DUKE POWER COMPANY

Re: Catawba Nuclear Station
Docket Nos. 50-413 and 50-414
McGuire Nuclear Station
Docket Nos. 50-369 and 50-370

Attached herewith are twenty (20) copies of Revision 14 to Duke Power Company's report, "An Analysis of Hydrogen Control Measures at McGuire Nuclear Station". As noted in Revision 9, this report is applicable to the Catawba Nuclear Station. This revision replaces Revision 13 in its entirety.

Response to questions transmitted by letter from NRC (B. J. Youngblood) to Duke Power Company (H. B. Tucker) dated December 17, 1985

FIGURE 1

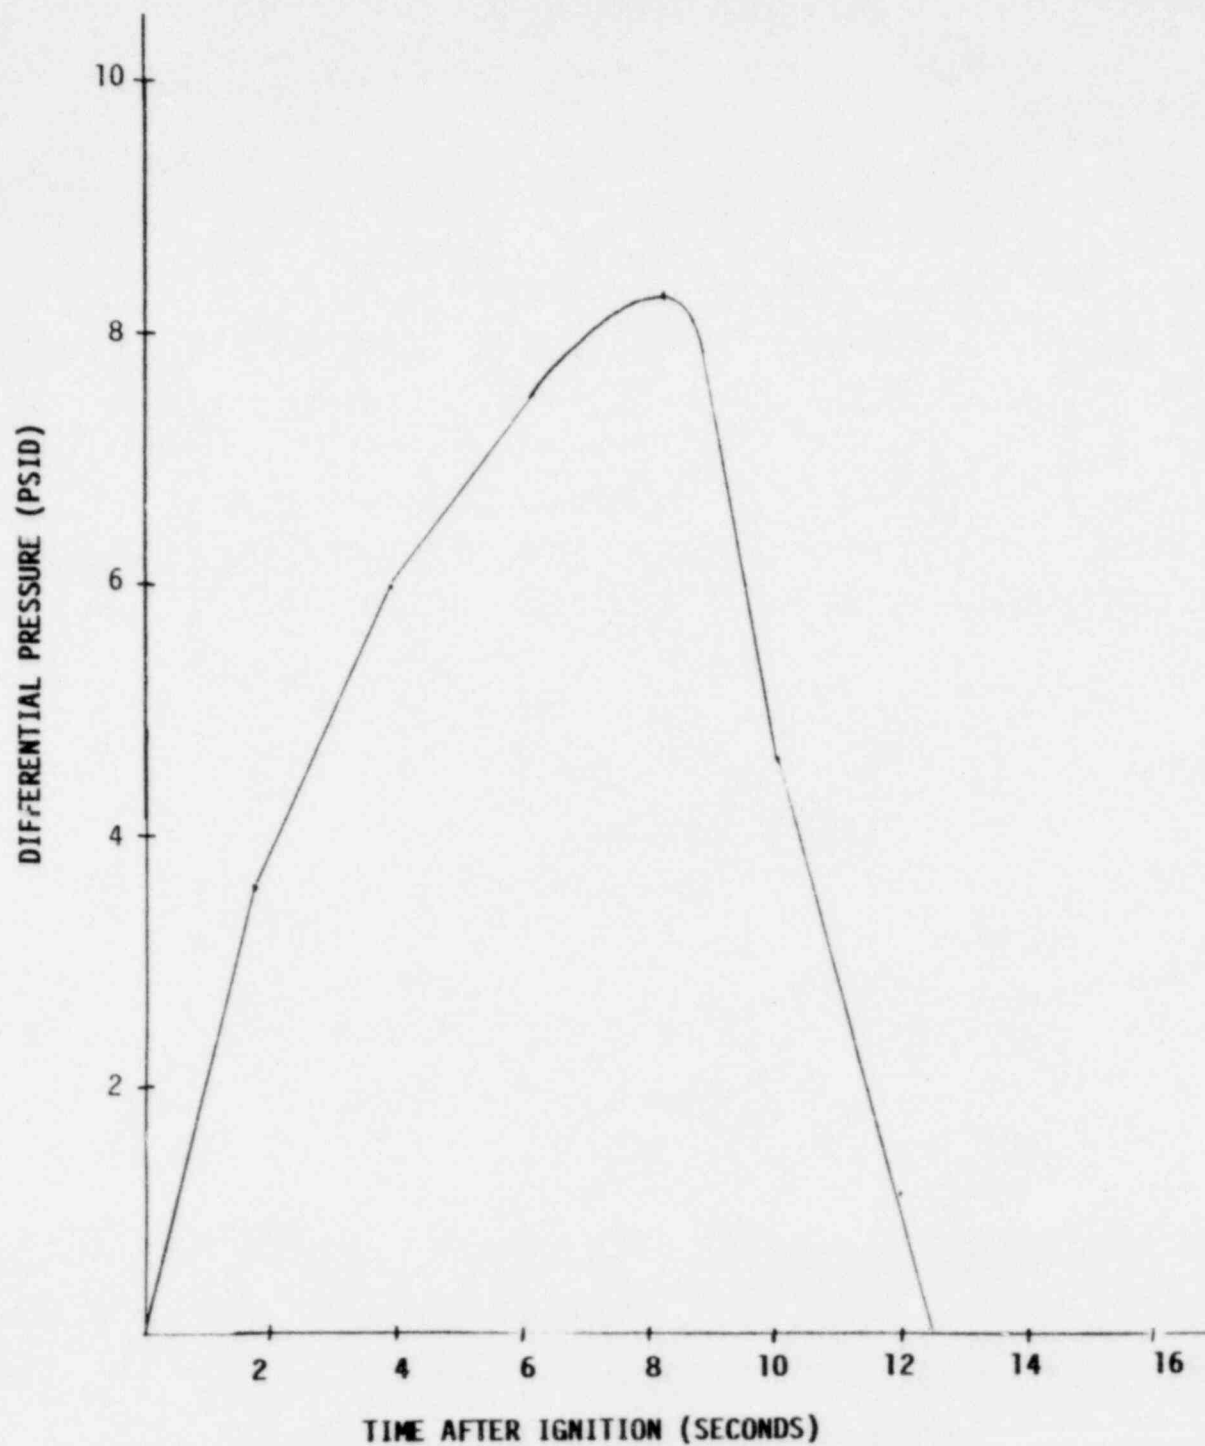
1. Provide details of the fan response calculation to support the statement in Duke's March 29, 1985 letter that burns occurring at hydrogen concentrations of 6.5% or less do not create sufficient pressure differential across the fans to speed them up to synchronous speed. Include in your response a description of the hydrogen combustion assumptions (e.g., flame speed, burn completion, compartment venting, containment spray, heat removal), and the fan and electrical system models and assumptions.

Under these conditions, a differential pressure transient with a peak of 8.1 psid and a duration of 12 seconds was imposed on the air return fans. A time plot of this transient is shown in Figure 1.
